In the Matter of
Carolina Power & Light Company and North
Carolina Eastern Municipal Power Agency
(Shearon Harris Nuclear Power Plant)
Docket No. 50-400-66

Enclosed are the replacement pages that constitute "Change 2" to the North Carolina Emergency Response Plan in Support of the Shearon Harris Nuclear Power Plant. As explained in the accompanying Memorandum from the Director of the North Carolina Division of Emergency Management, these pages should be substituted for pages in Revision 1 which was issued in September 1984. The areas of text changed are indicated by a line in the margin of the pages.

SUBJECT: Change 2 to the North Carolina Emergency Response Plan in support of the Shearon Harris Nuclear Power Plant, Revision #1 dated September 1984.

ATTACHMENT 4
CP&L EMERGENCY ACTION LEVEL
AND PROTECTIVE ACTION FLOWCHARTS

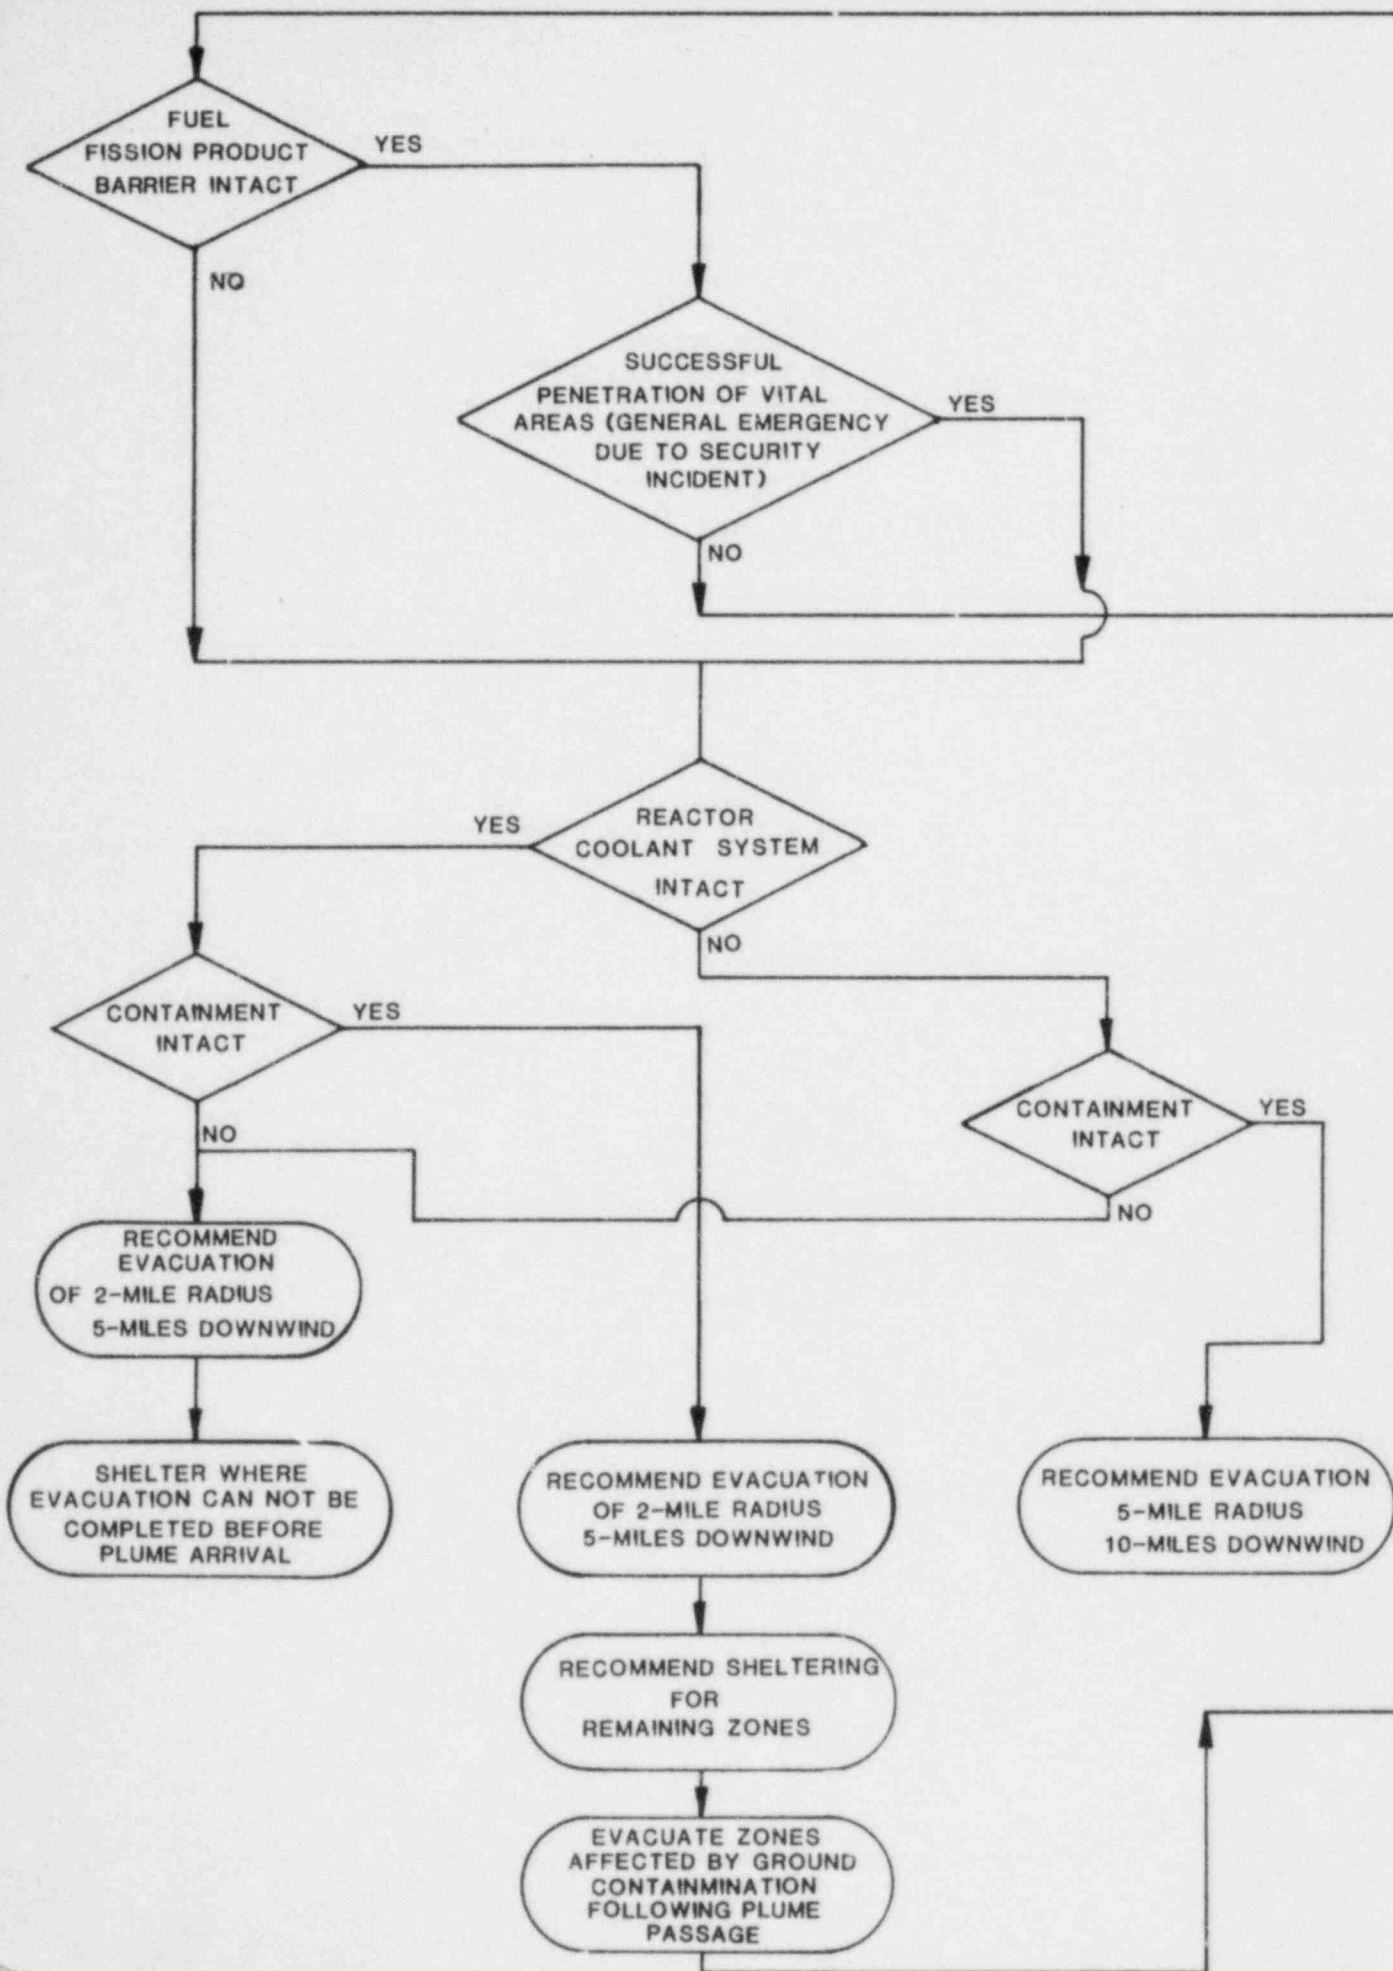
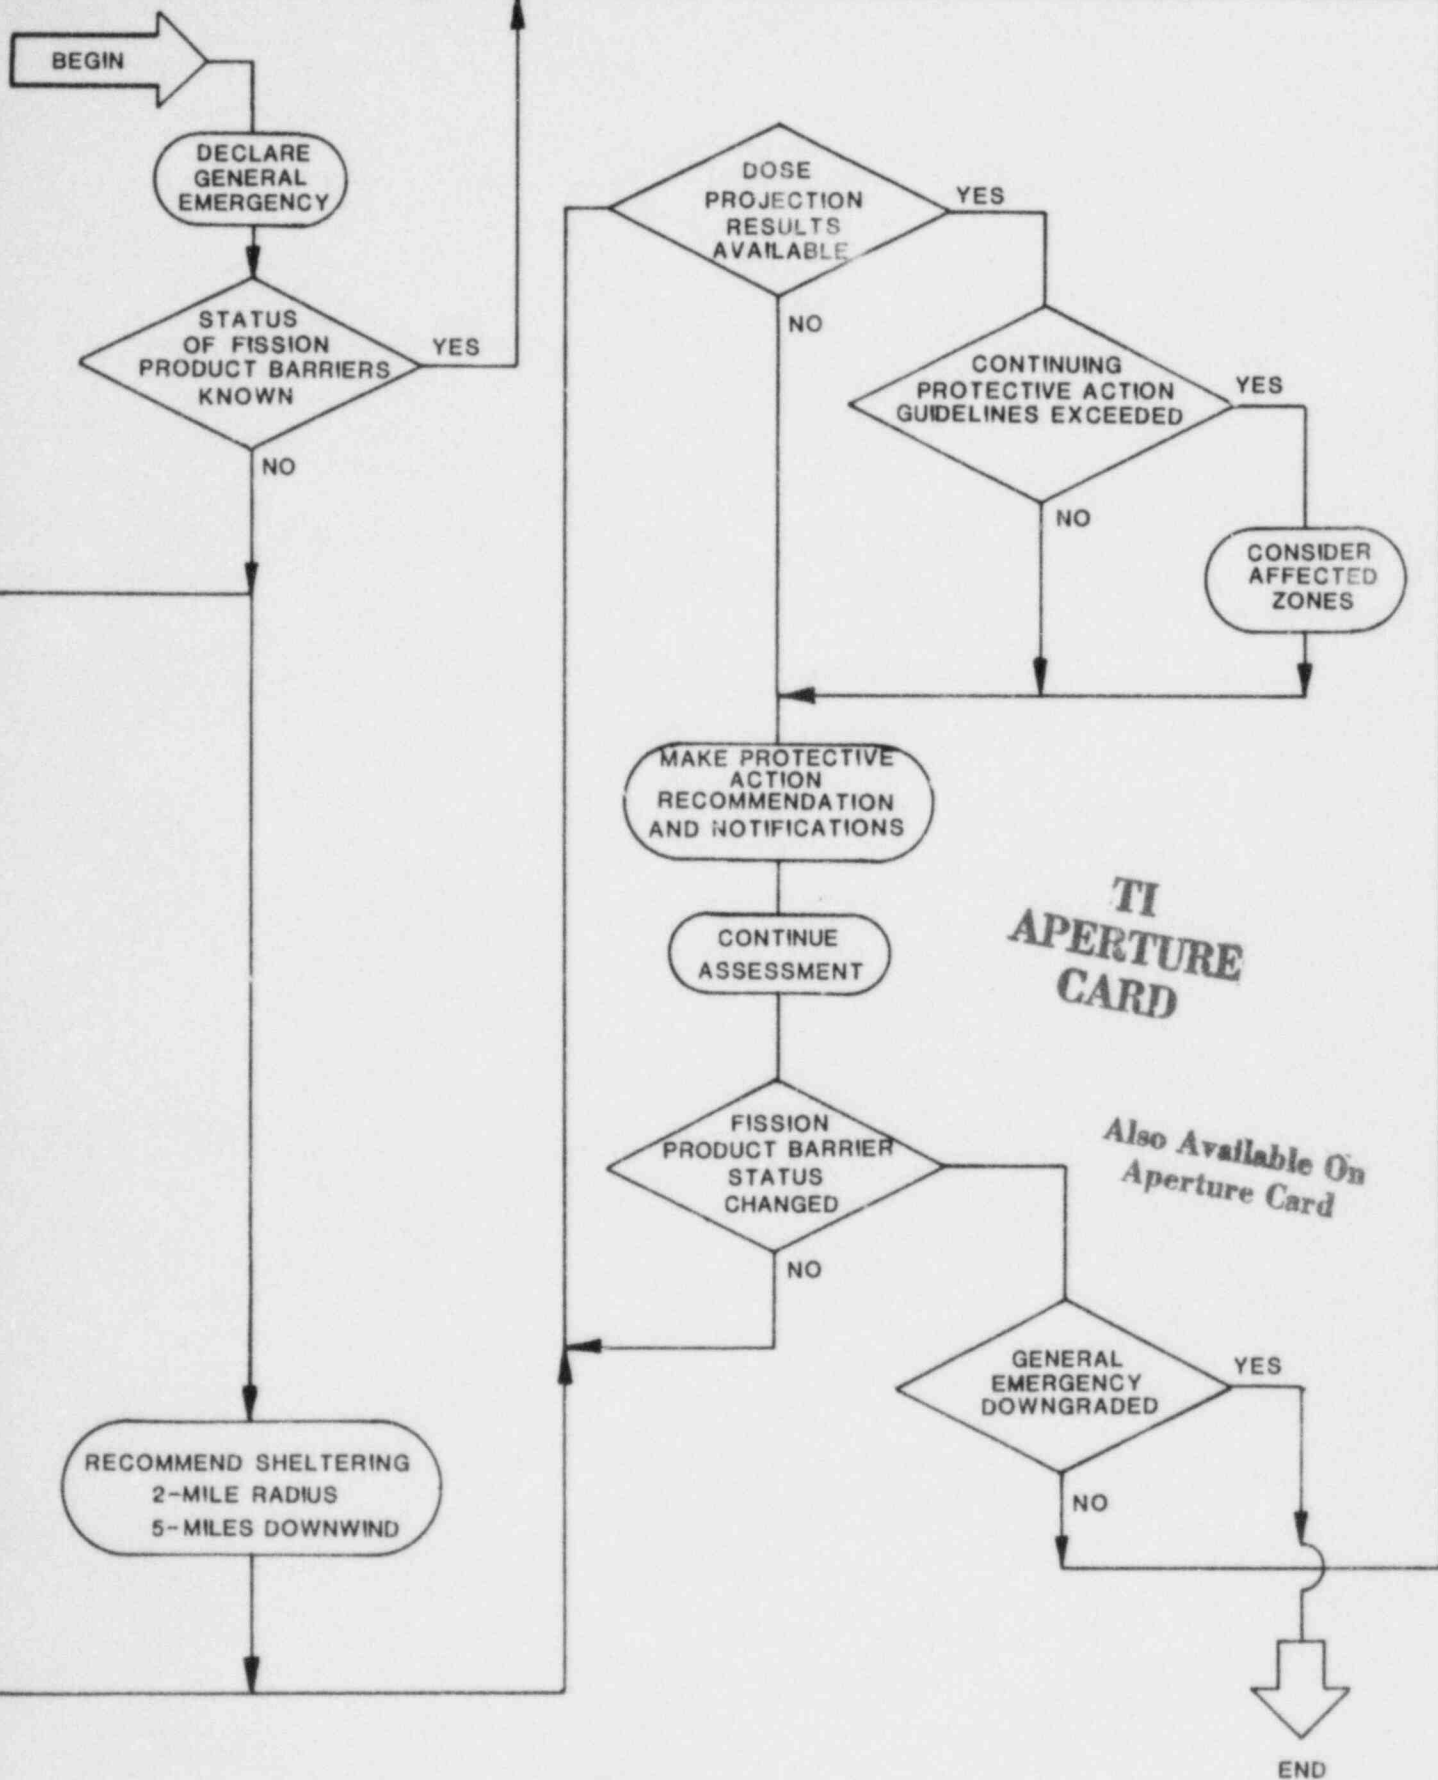
a. Page XI add Attachment 4. CP&L Emergency Action Level and Protective Action Flowcharts.

6. An integrated set of flowchart instructions utilized by the Shearon Harris Nuclear Power Plant to classify an Unusual Event, Alert, Site Area Emergency and General Emergency conditions is provided for information as Attachment 4, this part. The emergency action level network can be entered at points T,U,V and W indicating potential or actual loss of one (1) or more fission product barriers. This same network can be entered at points X,Y and Z for other emergency conditions not directly related to fission product barrier status. Once a General Emergency condition is reached, offsite protective action recommendations will be made by Carolina Power and Light Company using the flowchart as contained in Attachment 4, this part.
